Access Compliance Report

Public Rights-of-Way

| Intersection ID: 12937 | Main Street: E_W_T_HARRIS_BV | Cross Street: HICKORY_GROVE_RD | Location: NE |
| ADA ID: 1B3D8B7BAF7D | Ramp Type: Perp | Initial Pass/Fail: Fail | Overall Compliance: No |

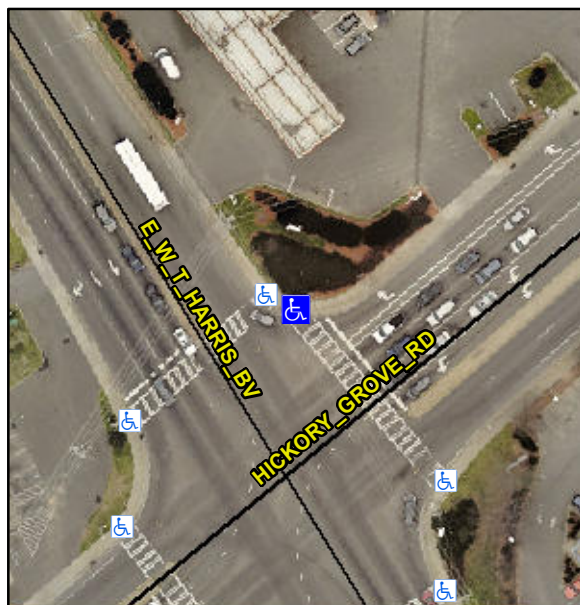
Not Found, R304.5.1

| Compliance | Description | Data | Compliance | Description | Data |
|------------|-----------------------|-------|------------|-----------------------------|------|
| No | Ramp Width (in) | 47.5 | Yes | Ramp XSlope (%) | 1.1 |

Remove & Replace Entire Ramp.
